AMC Knit Composite Ltd. (Extension - 2)

Structural Inspection Report

6 storied Chemical Building 6-storied (G+5) RC building.

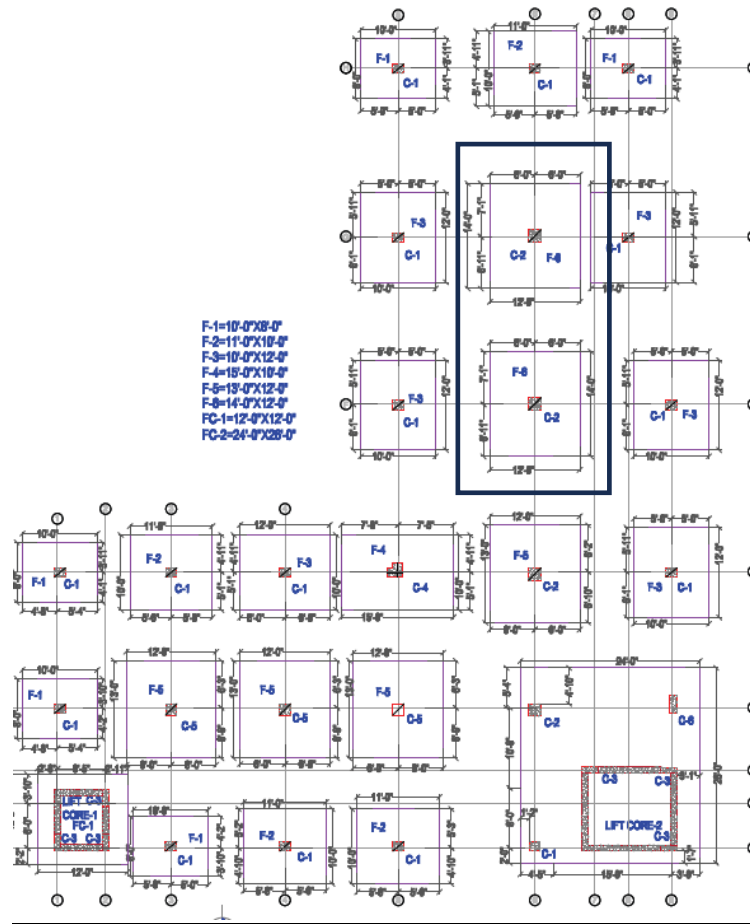
Observation 01: Marginally stressed above normal design limit in foundation (6-storied Chemical Building).

Description: cursory calculation indicates that stress in the foundation exceeds the normal design limit in the highlighted foundation (marked in the layout) for the 6-storied structure. At the time of inspection, design documents (design report, load plan, and adequate material test reports) were also unavailable.

Building engineer is required to perform in-situ material strength, review the design of the foundation stress and prepare a Detail Engineering Assessment (DEA) report with a proper remediation plan and submit to RSC for review.
